# WATER QUALITY MEMORANDUM

## Utah Coal Regulatory Program

RE: Second Quarter 2015 Water Monitoring, PacifiCorp, Deer Creek Mine.  
C/015/0018, Task ID #4913

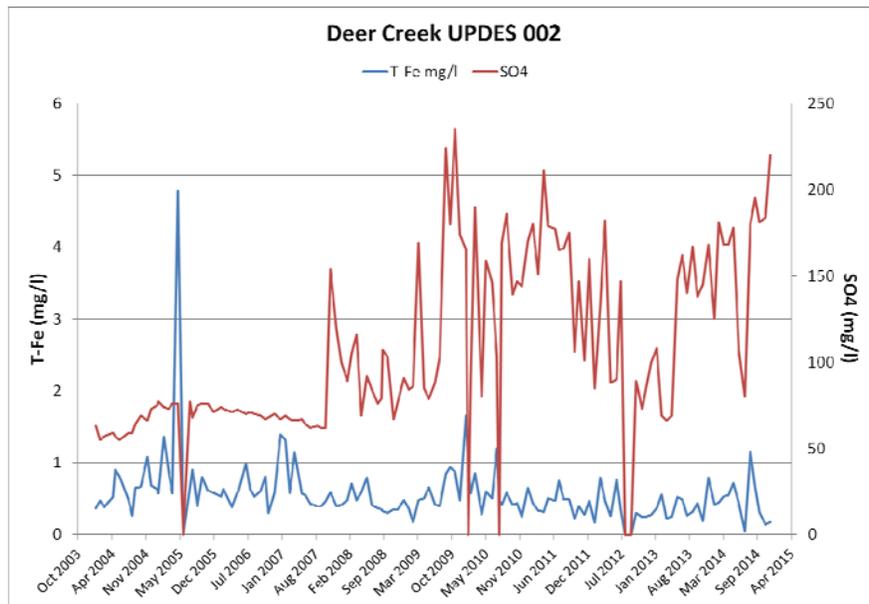
Discharge at the UPDES outfalls will change dramatically in the coming quarters. The south half of the Deer Creek mine has been sealed. The pumps in the Mill Fork lease that produced the vast majority of in-mine dewatering were shut off as of mid-2015.

This graph is currently not applicable. There is no discharge from the Deer Creek mine. Once the gravity drainage reaches the Deer Creek portals this graph should be updated.

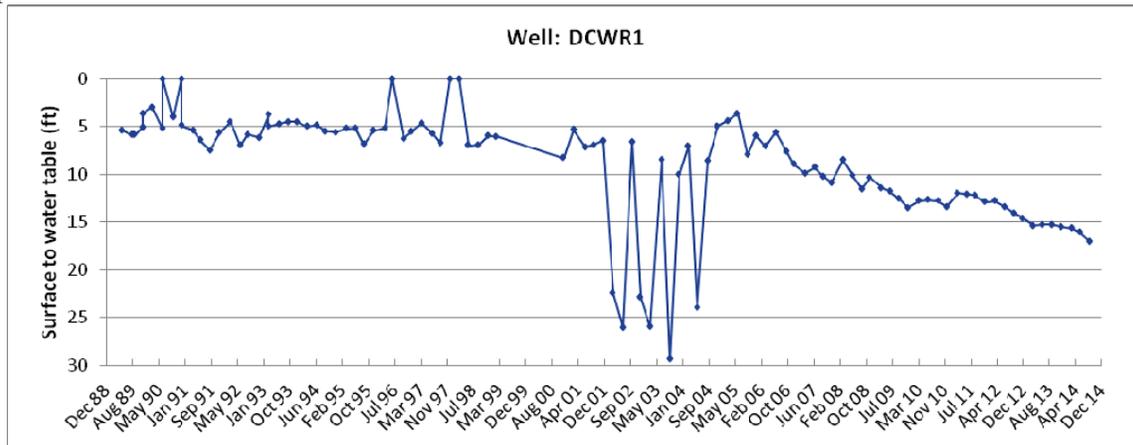
The water temperature at Main North Main East varies seasonally year-after-year (see following chart), indicating that this in-mine source is most likely fed by infiltrating surface water rather than draining surrounding strata. The temperature at TW-10 shows some seasonal variation, but it is not as definitive as at Main North Main East.

This will probably be the last quarter of in-mine sampling. As of mid-2015 these sampling locations are no longer accessible.
